NEW YORK CITY DEPARTMENT OF CORRECTION

**ADDENDUM #4 PIN 072202009CPD**

**George R. Vierno Center (GRVC) State of Good Repair**

**DESCRIPTION OF CHANGES**

**A-301.00**

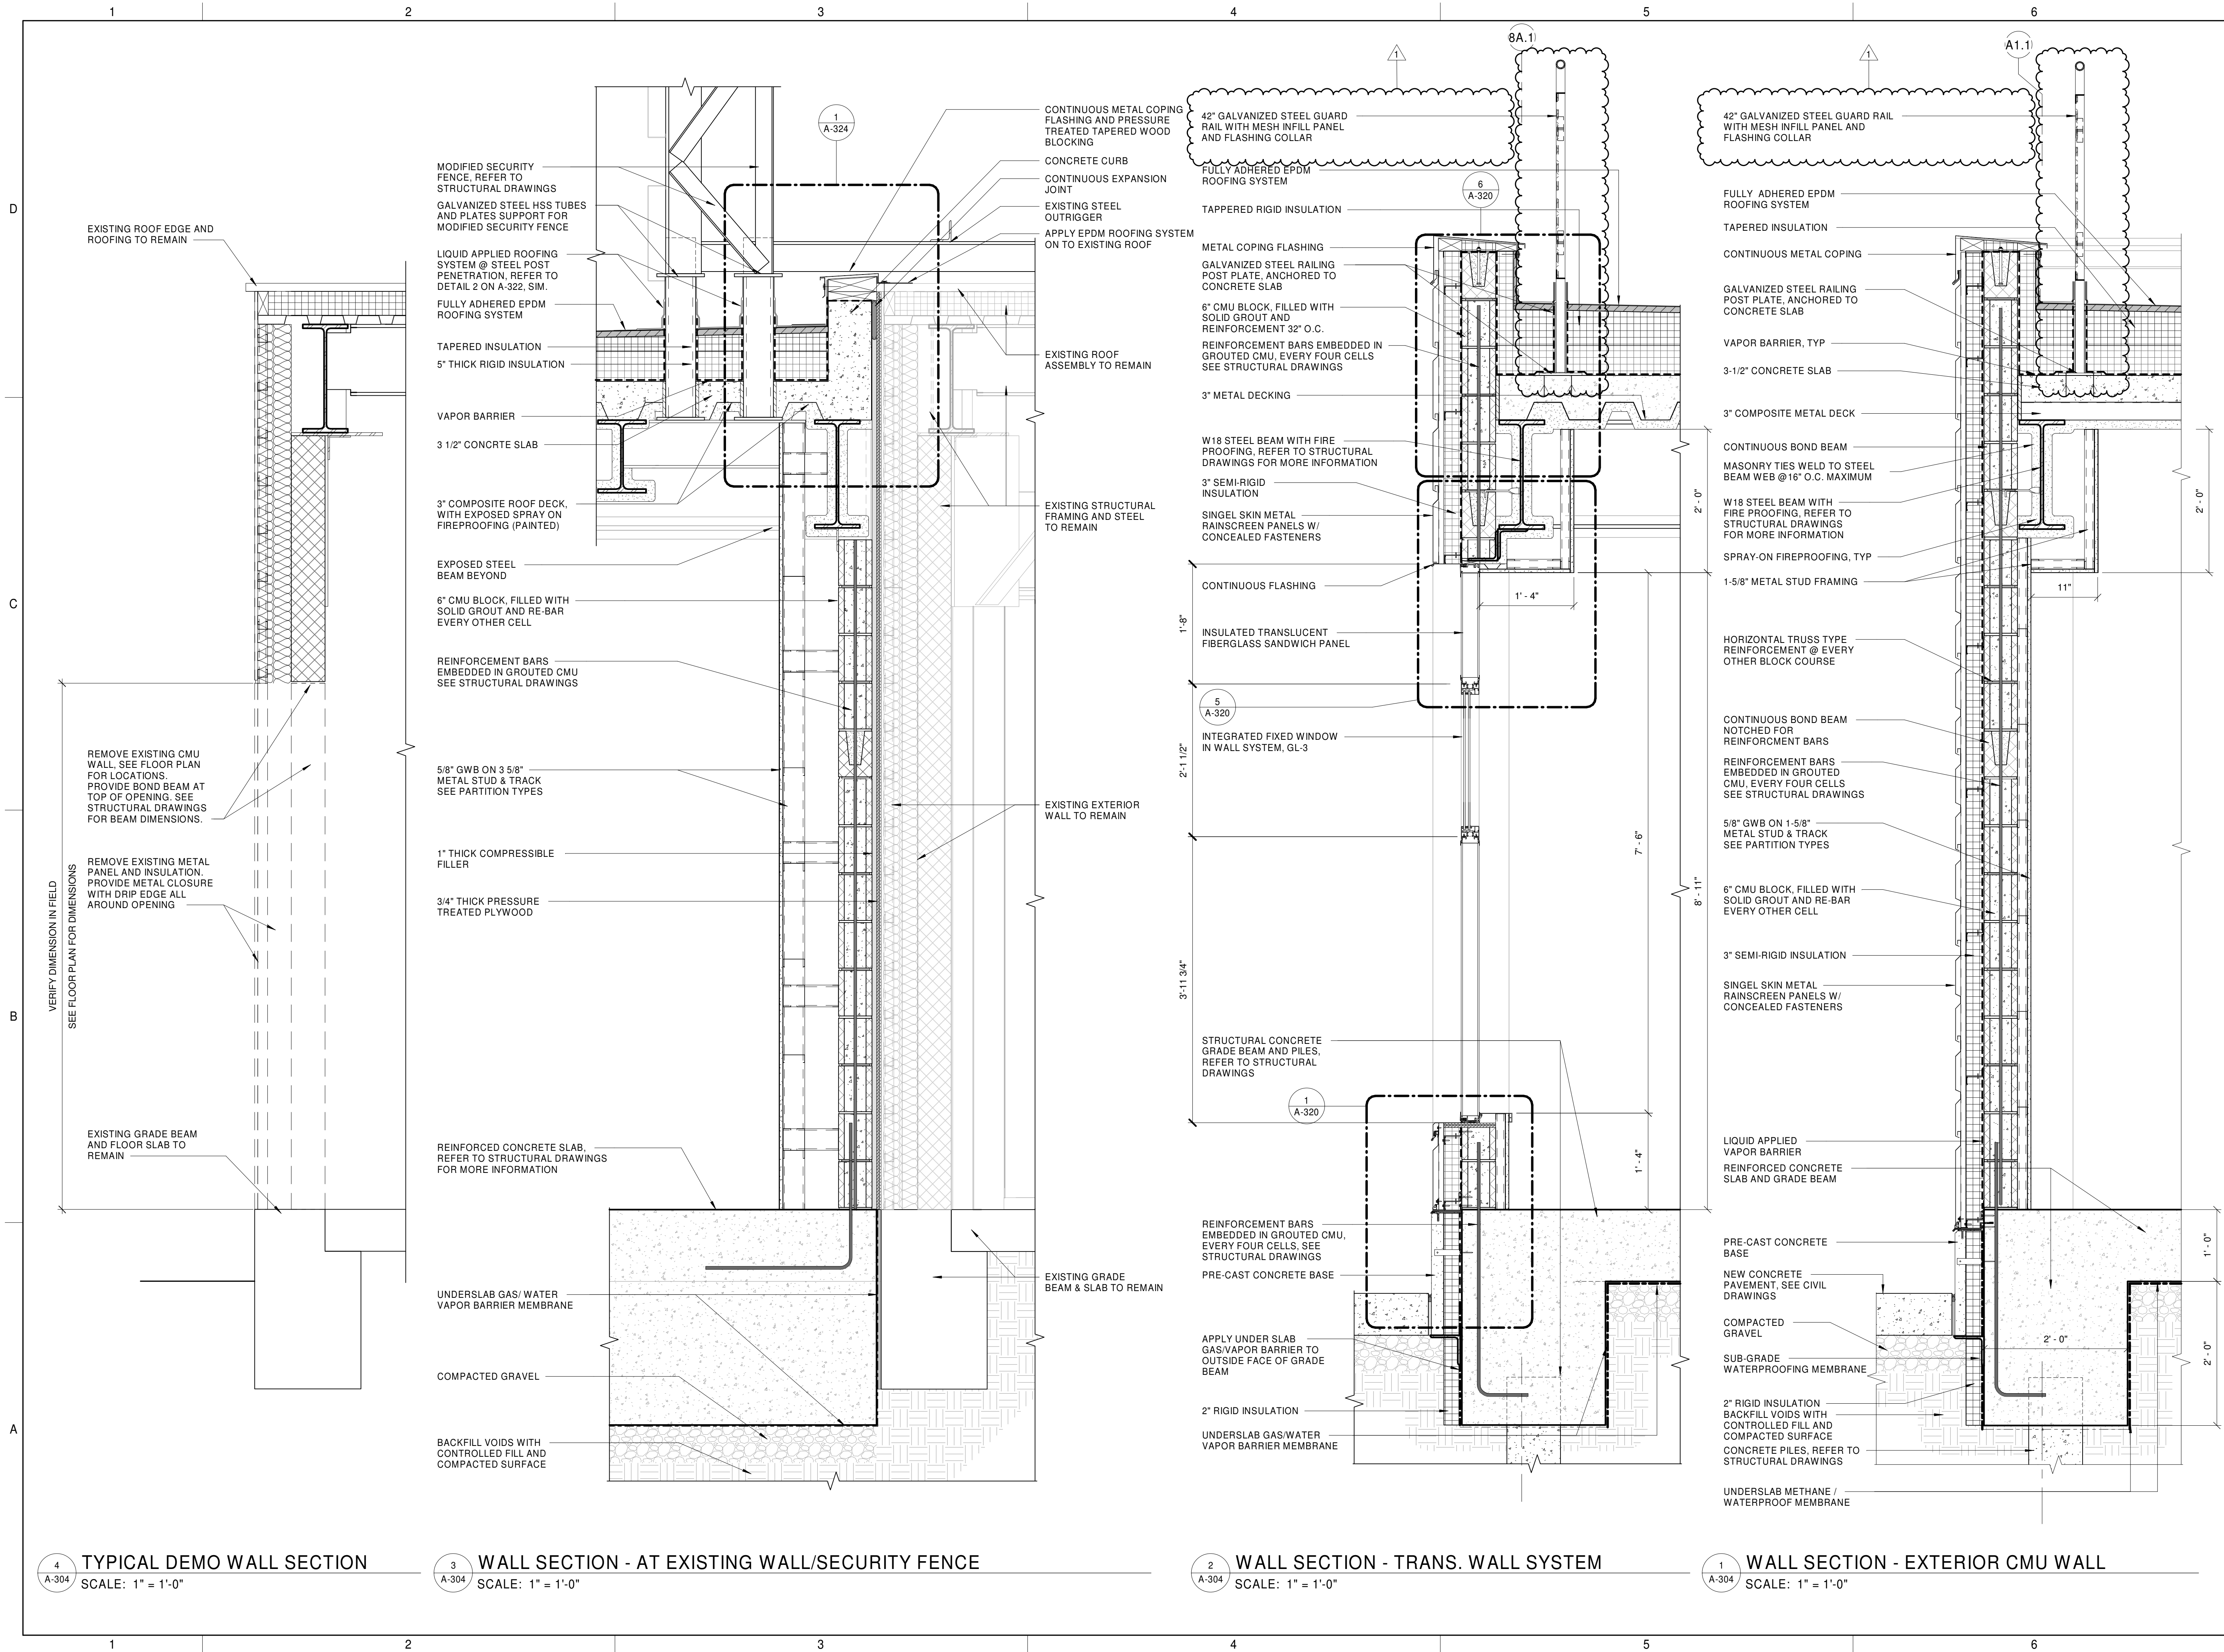
1. **A-301.00:** Added Mesh Infill Panels at the Roof Guardrail on the Elevations.
2. **A-304.00:** Added Mesh Infill Panels at the Roof Guardrail on the Wall Sections.
